CHRYSLER A604 (41TE) UPDATE HANDBOOK

**AUTOMATIC TRANSMISSION SERVICE GROUP
9200 S. DADELAND BLVD. SUITE 720
MIAMI, FLORIDA 33156
(305) 670-4161**

"UPDATE HANDBOOK"

Figure 1

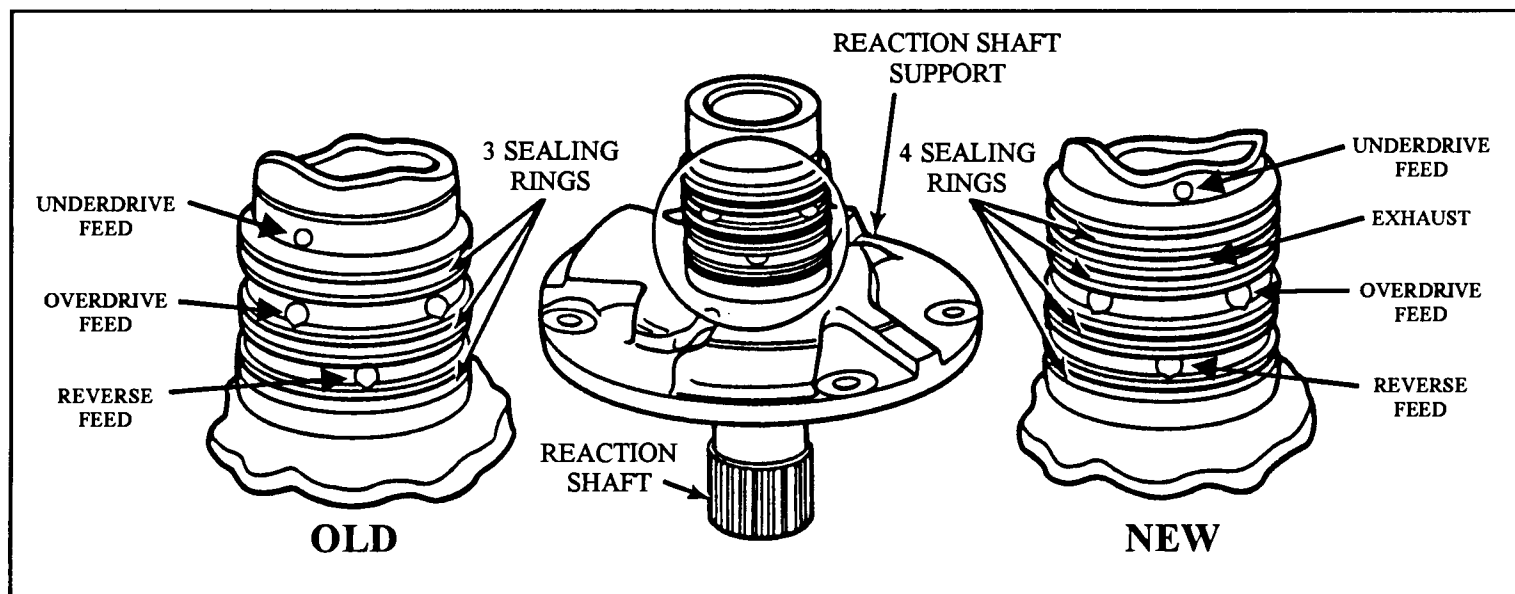
CHANGE: Beginning in April, 1989 a new Reaction Shaft Support (Stator) was introduced, with the addition of another ring groove and sealing ring. The old support has 3 sealing rings, and the new support has 4 sealing rings (See Figure 1).

- (1) **REACTION SHAFT SUPPORT** - The new support is longer, and has 4 sealing rings, where the old support only has three (See Figure 1).
- (2) **INPUT SHAFT/CLUTCH HUB** - The new Input Clutch Hub bore is machined deeper to accommodate the additional length of the reaction shaft, created by the added sealing ring (See Figure 2). The "O" Ring grooves are also cut shallower than the old input clutch hub, which increases the groove diameter, and provides improved compression or "Crush", between the "O" rings and the input clutch retainer. (See Figure 3).

Figure 3

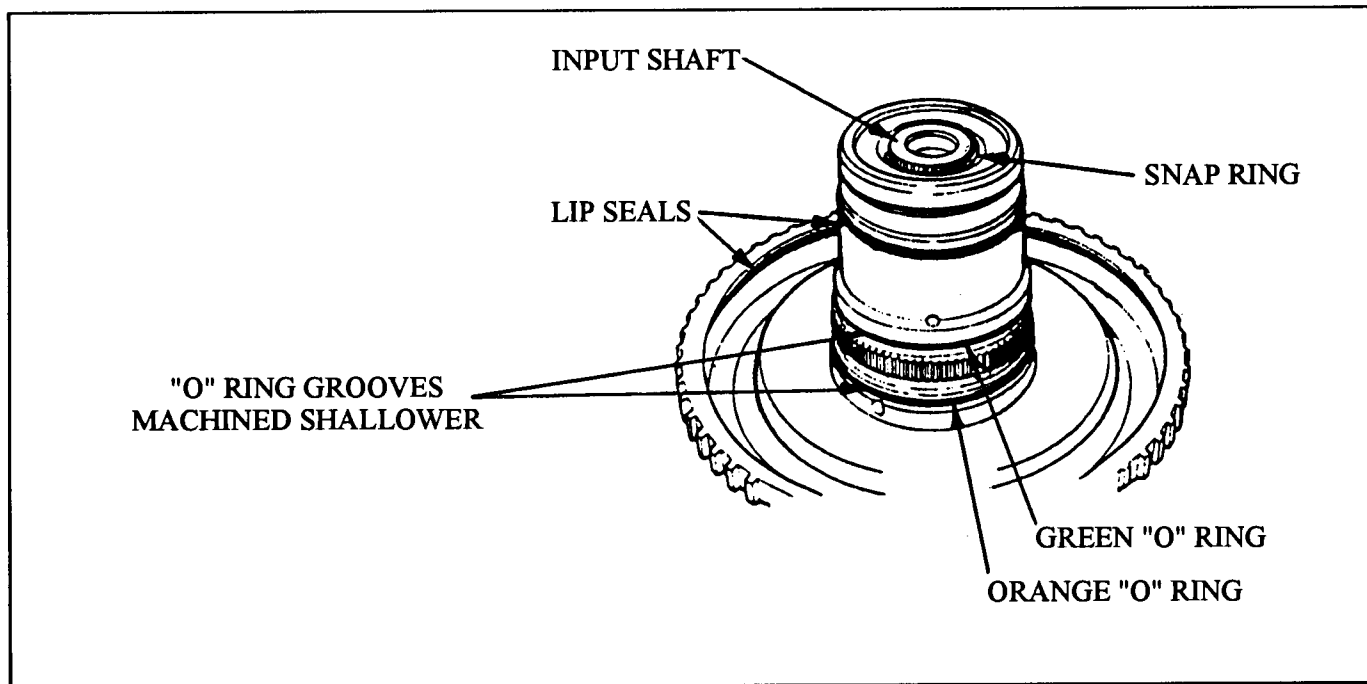
- (3) **INPUT SHAFT/CLUTCH HUB "O" RINGS** - The new "O" Rings are "Teflon Coated" for greater tear resistance during the assembly process. The coatings also identify the locations for the "O" Rings. The orange ring goes to the front, and the green one goes to the rear (See Figure 3). The early "O" rings were black.

Figure 4

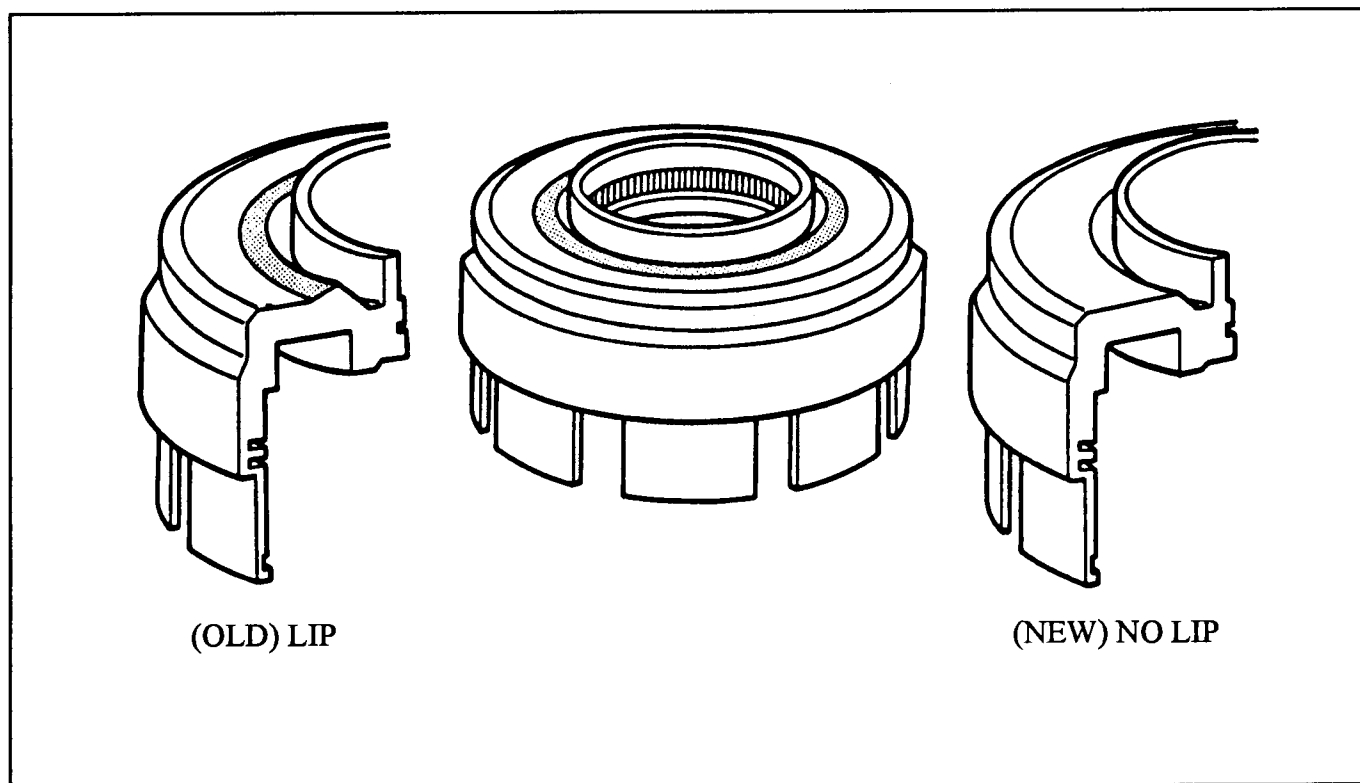
- (4) **INPUT CLUTCH RETAINER** - The Input Clutch Retainer was modified, by machining off the "Lip" (See Figure 4), to allow more travel of the overdrive/reverse piston. The old Input Clutch Retainer can be machined at the local machine shop if necessary.

Figure 5

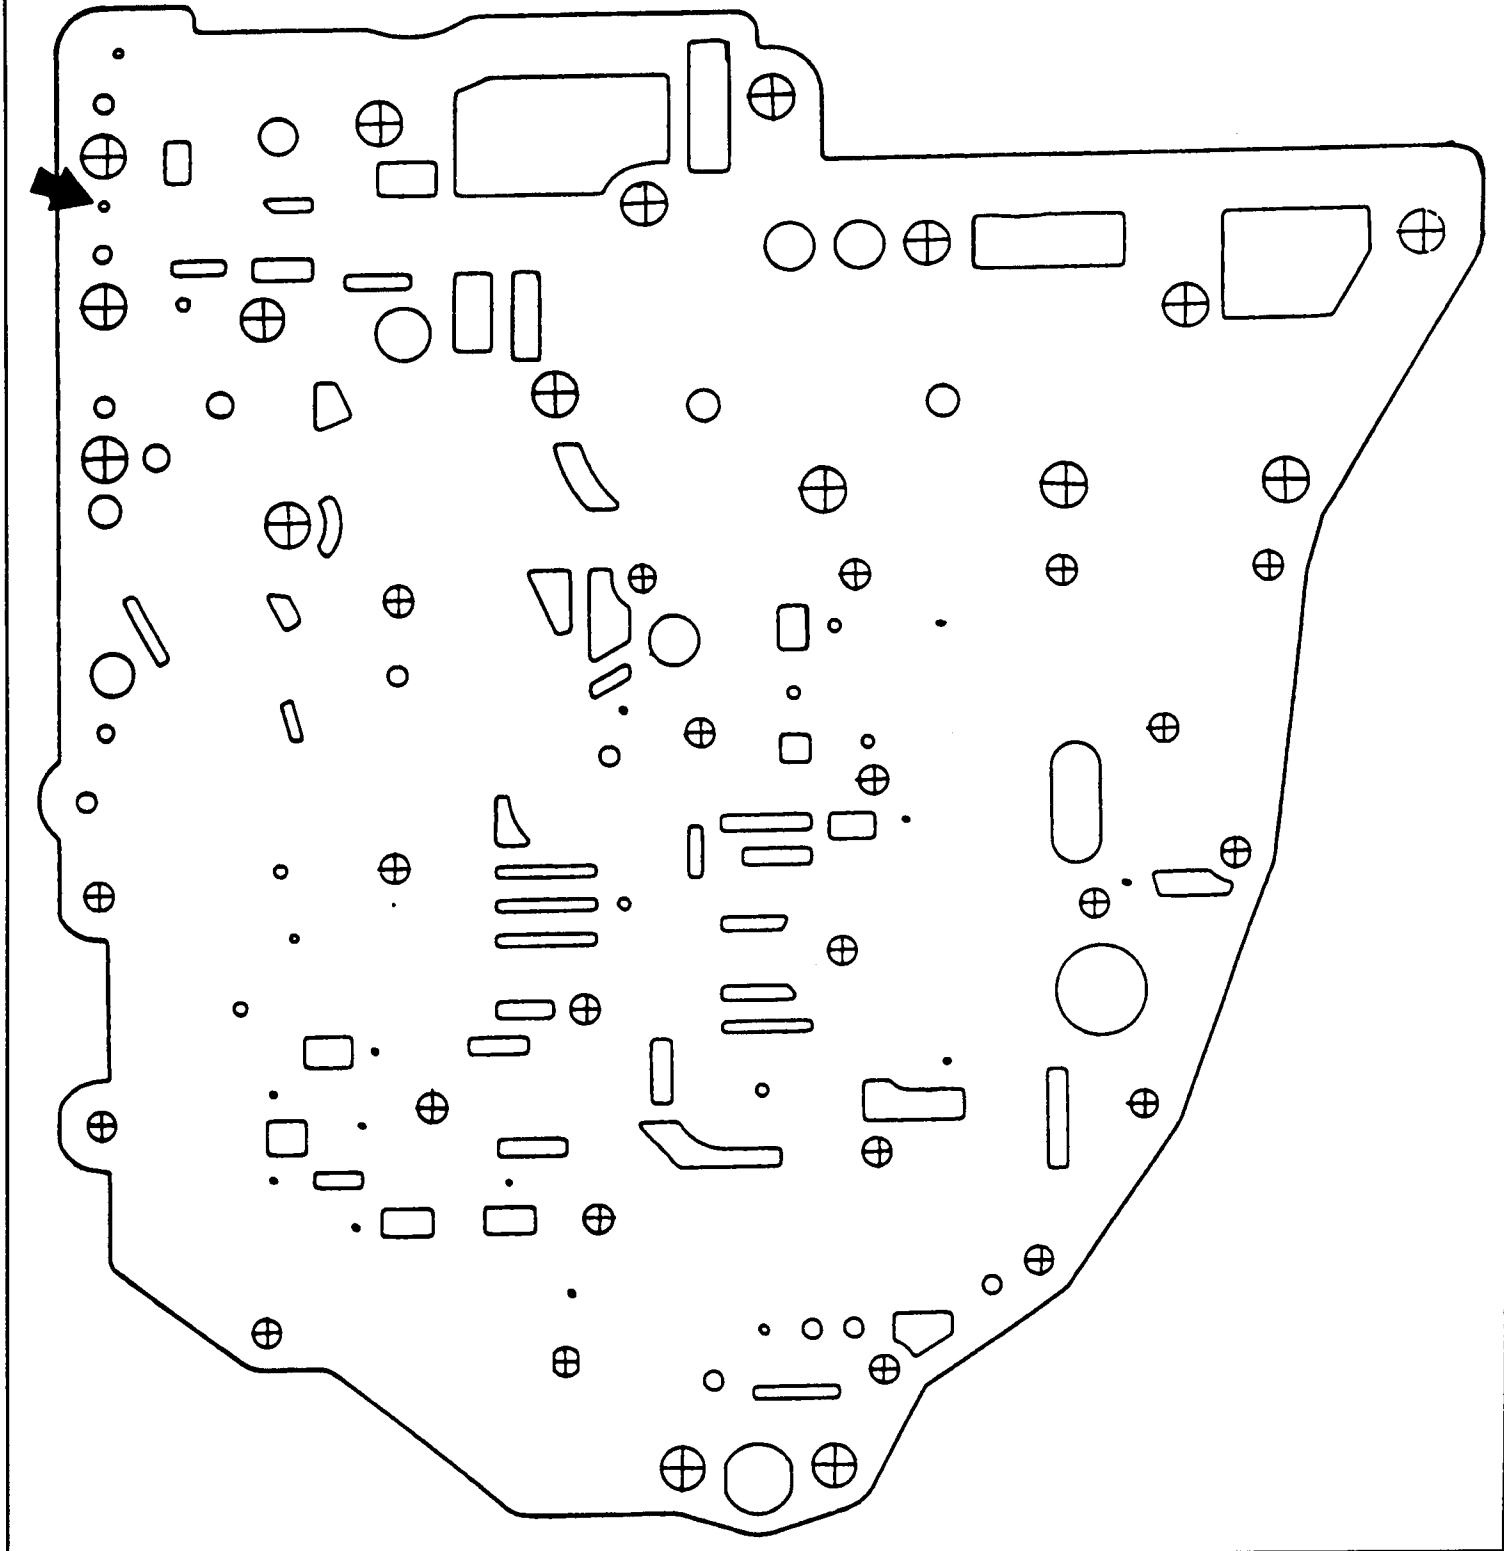
- (5) **SPACER PLATE** - The new Spacer Plate has a larger (.105") overdrive clutch feed orifice to provide increased oil flow to the overdrive clutch circuit (See Figure 5).

THE HOLE INDICATED BY THE ARROW BELOW HAS BEEN ENLARGED TO .105" FOR INCREASED OIL FLOW TO THE OVERDRIVE CLUTCH CIRCUIT.

Figure 6

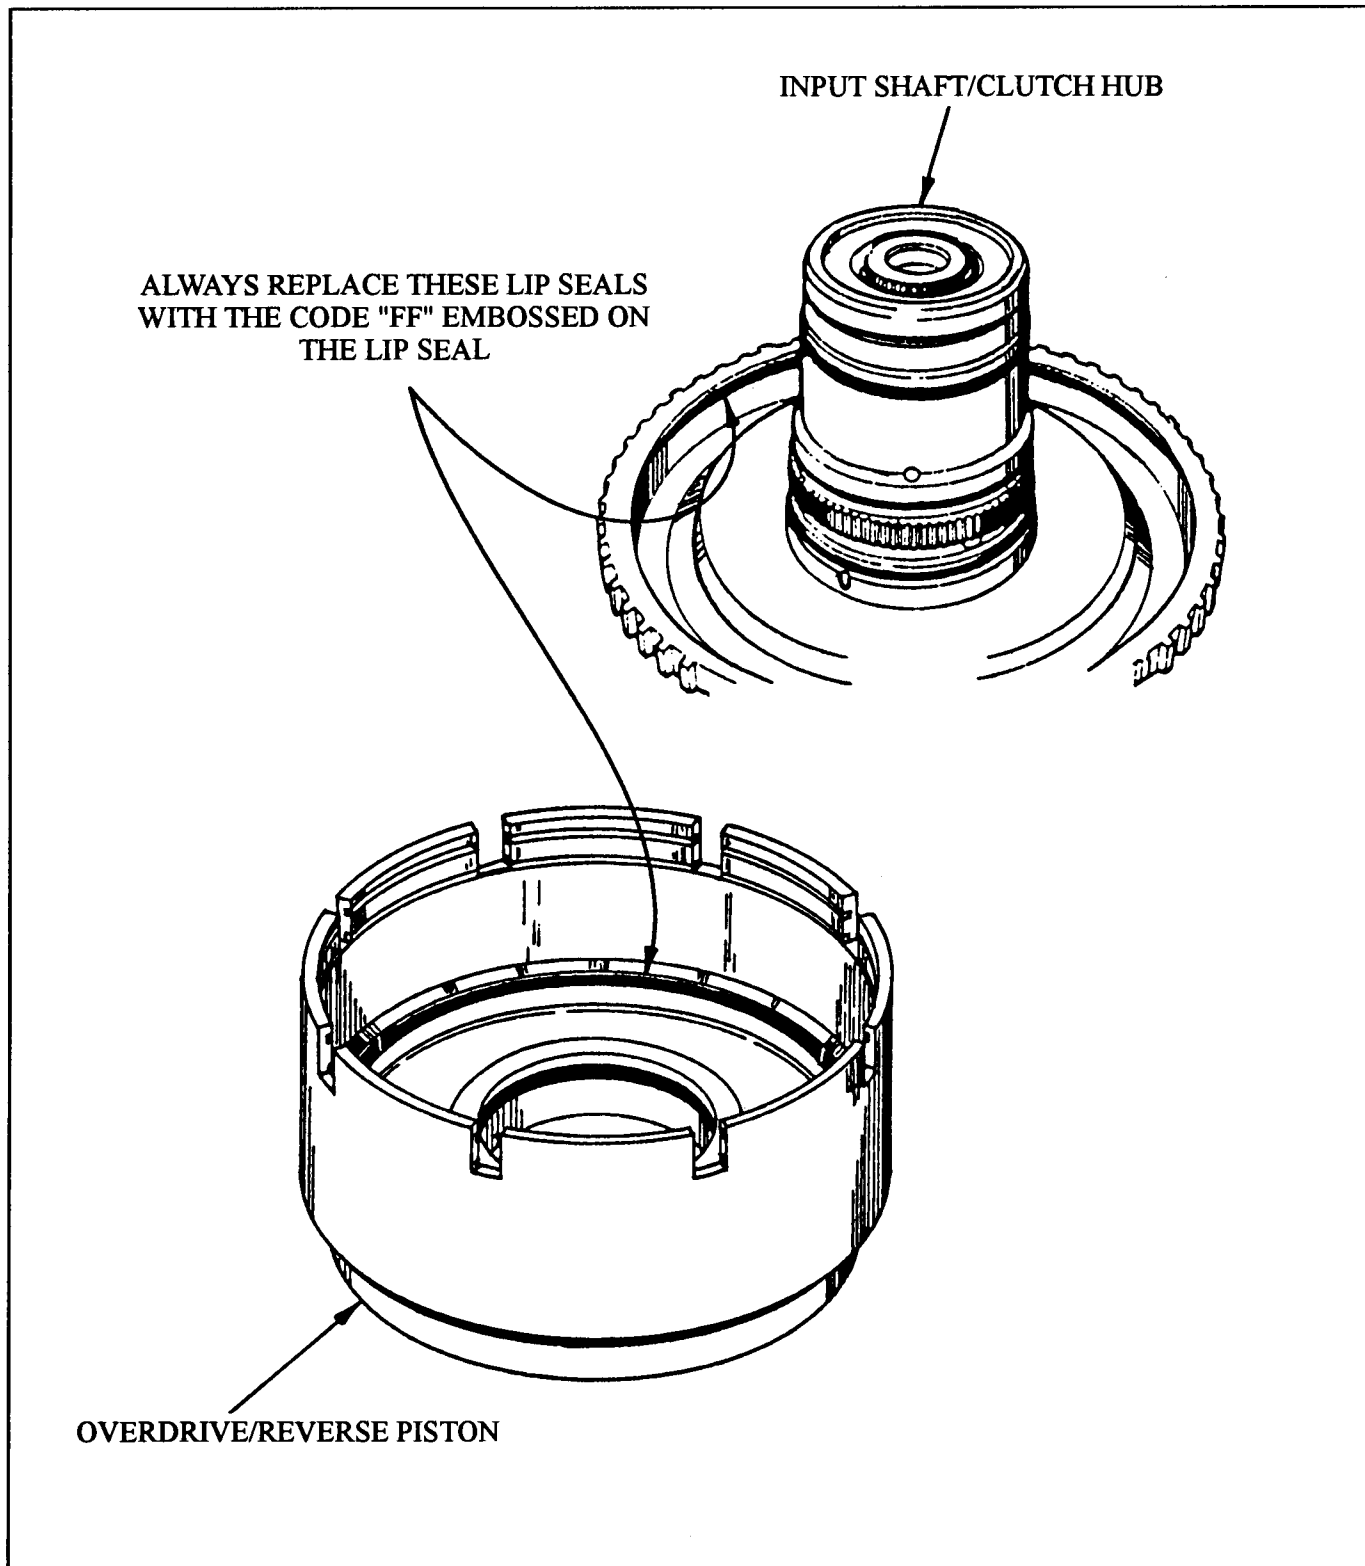
CHANGE: The lip seals in the Overdrive/Reverse Clutch Piston and the Input Shaft/Clutch Hub are now replaced with lip seals made of different material (See Figure 6).

- (1) OD/REVERSE PISTON LIP SEAL - No dimensional changes, but the material changes, and the new lip seals can be identified by the code "FF" embossed into the seal. The old lip seal is embossed with the code "IPC", and should not be used (See Figure 6).
- (2) INPUT CLUTCH HUB OUTER LIP SEAL - No dimensional changes, but the material changes, and the new lip seals can be identified by the code "FF" embossed into the seal. The old lip seal is embossed with the code "IPC", and should not be used (See Figure 6).

THE NEW LIP SEALS EMBOSSED WITH THE CODE "FF" WILL RETROFIT BACK TO ALL PREVIOUS MODELS, AND SHOULD BE USED DURING OVERHAUL.

Figure 14

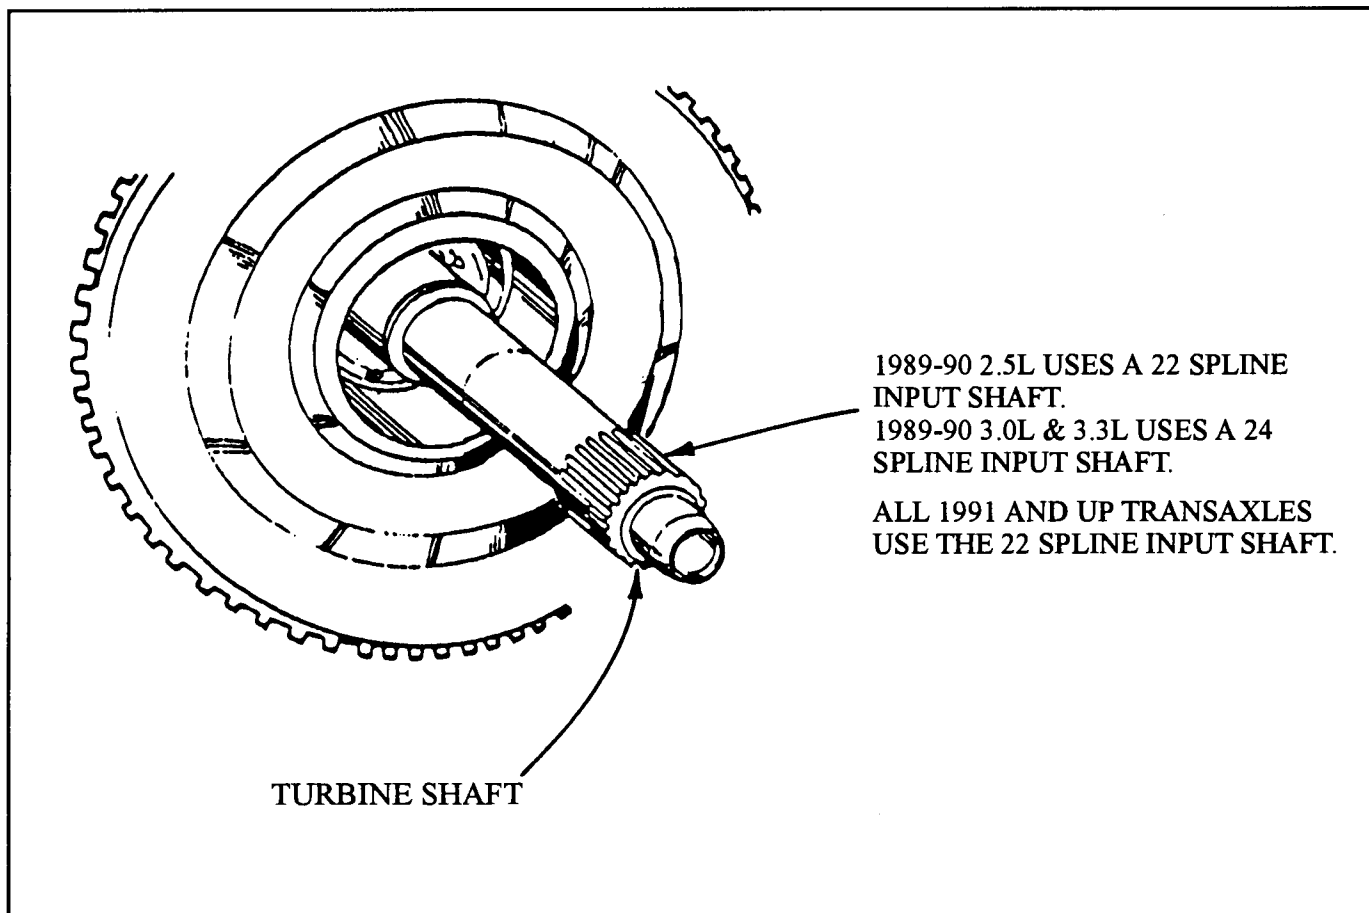
- (2) **TURBINE SHAFT SPLINES** - 1989-1990 2.5 Litre engine uses a turbine shaft with 22 splines for the torque converter, and the 1989-1990 3.0 and 3.3 Litre engines will use the a 24 spline turbine shaft (See Figure 14).

NOTE: All 1991 and up A604 transaxles will use a 22 spline input shaft to fit a new torque converter with a torsional vibration damper (See Figure 14).
